Agenda Item :
Source : Siemens
Title : Text Proposal for Modifications of TS25.231 for TDD
According to OHG Harmonisation Agreement
Document for : approval

This Tdoc proposes changes to the TSG RAN WG1 technical specification 'Physical layer- Measurements' 25.231 (formerly S1.31) to adopt the OHG harmonisation agreement of reducing the chip rate from 4.096Mchips/sec (40960chips/frame) to 3.84Mchips/sec (38400chips/frame).

Figure 2: possible idle periods in a 16 TS frame with two occupied TS.

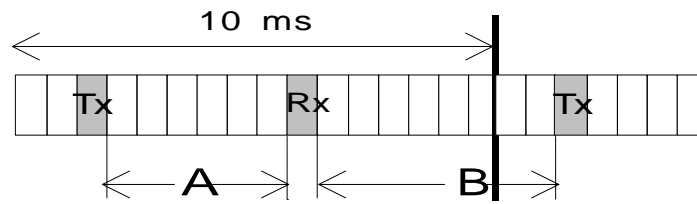
<Section 7.1.5.4.2.1 still considers a frame with 16 instead of 15 timeslots, therefore it should be updated or deleted.>
